# Optional Cable Resistance Measurement (CRM) - Part 2

GITESH BHAGWAT, ANDY GARDNER, HEATH STEWART  
SANTA BARBARA DESIGN CENTER

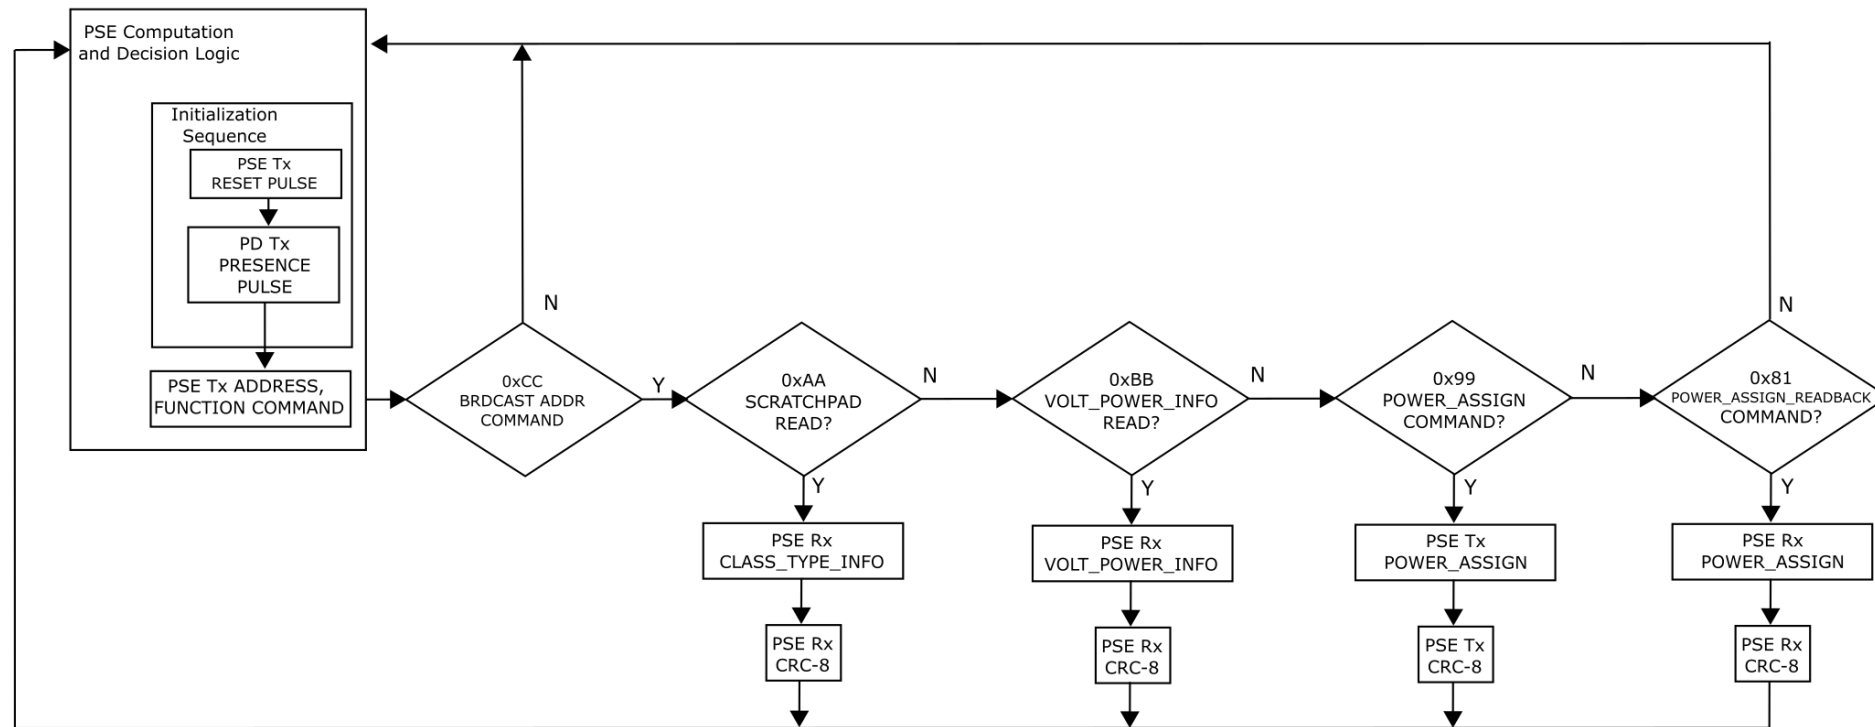
# Optional: Add SCCP command for PSE readback

- ▶ Add SCCP Command
  - 0x81 : POWER\_ASSIGN\_READBACK
- ▶ Replace Figure 104-13 with the figure shown on this slide
